DG Flugzeugbau GmbH 76646 Bruchsal **Technical Note** No. 843/25

Subject : Power plant ignition system

Effectivity : DG-500 M all Ser. No.'s.

Picture 1

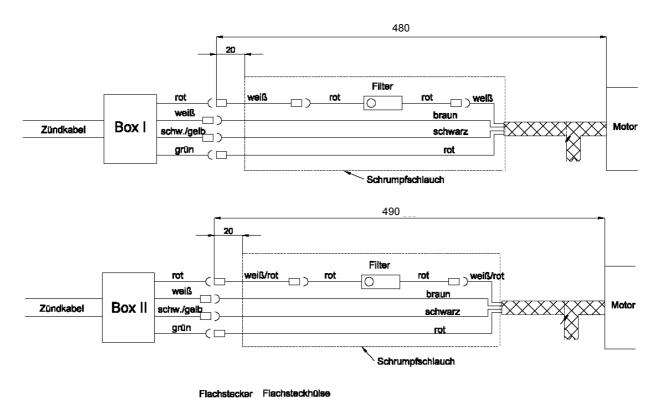
- 4. Plug an ignition box filter (pict. 1) to each of the two cable shoes. Slip heat shrink tubing over the connections and shrink the tubing. Take care of the correct mounting direction. (see pict.2).

Picture 2

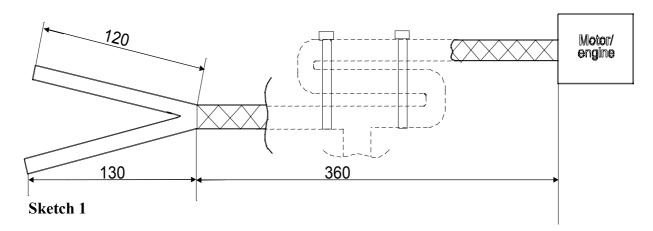
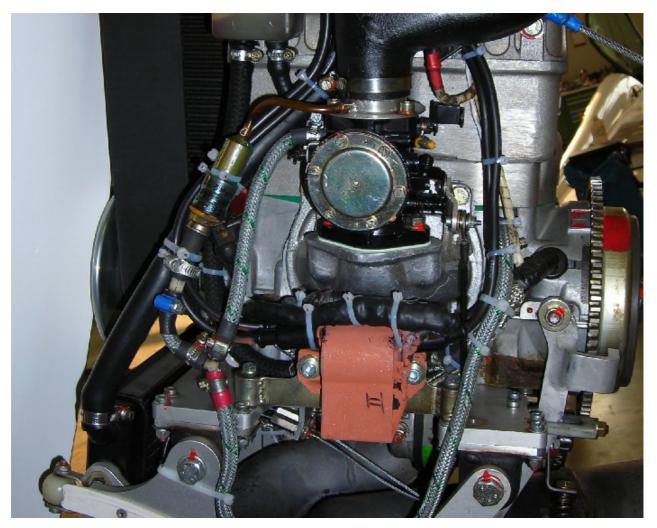
- 5. Crimp a spade connector (male) on each of the wires remaining from point 2. Connect the wires according to pict.2 to the filters, so that you have the same wire colours as on the other side of the filter.

- 6. The cable harness for the ignition box aft (BOX I) has to be shortened to 480 mm (pic.2). The cable harness for the front ignition box (BOX II) has to be shortened to 490 mm (pic.2). Slip heat shrink tubing over the cable harness as indicated in picture 2 and shrink the tubing. Note: 20mm of the wires must not be covered by the heat shrink tubing see pict.2.

- 7. Crimp cable shoes to the wires according to pict.2
- 8. Connect the wires to the ignition boxes according to pict.2.
- 9. Slip heat shrink tubing over every connection.

Warning: don't mix up the wire colours!

Picture 3

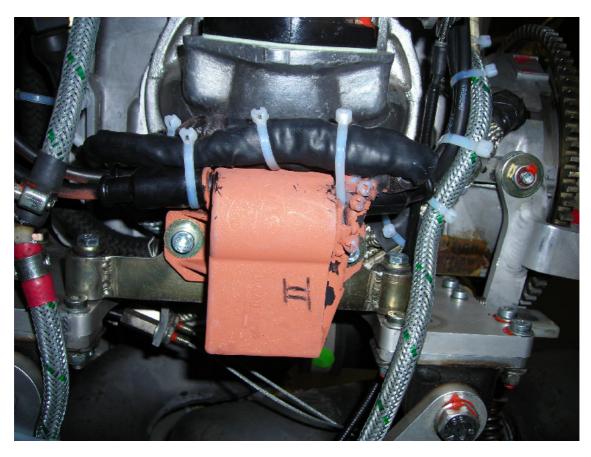
- 10. Cover the cable harness completely with heat shrink tubing.
- 11. The cable harness has to be fixed. The cable harness should not be able to vibrate or rub. Fix the cable harness according to pictures 3, 4 and 5 and drawing 5M74. The ty-raps have to tightened by hand.
